**Melton
Borough
Council**

Planning Committee

20/00452/REM 32no.dwellings including garages and carparking, new site access and proposed landscaping strategy (reserved matters application relating to 16/00100/OUT)

Field OS 3300, Oakham Road Somerby

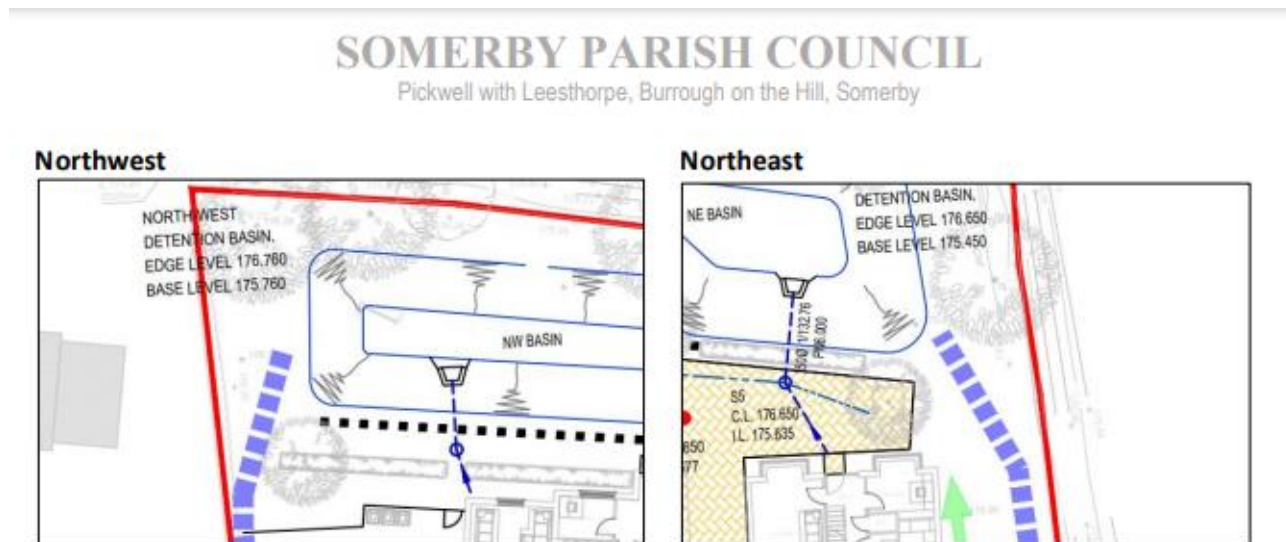
"The central area of the site is shown to be raised above current ground levels. As there is no ditch to the west side runoff in that direction will drain over land onto adjacent ground.... Due to the absence of a ditch on the west side flooding is expected there which consists of residential gardens on Firdale and Oakham Road.' (para 4.5)

'The proposed runoff to the west of the site needs to be addressed as flooding of the adjacent land, which consists of residential gardens, is expected.' (para 5.0)

The application proposes to deal with the above with the Filter Drain and Catchwater ditches, but this proposal lacks detail and would be ineffective as drawn. We discuss this next.
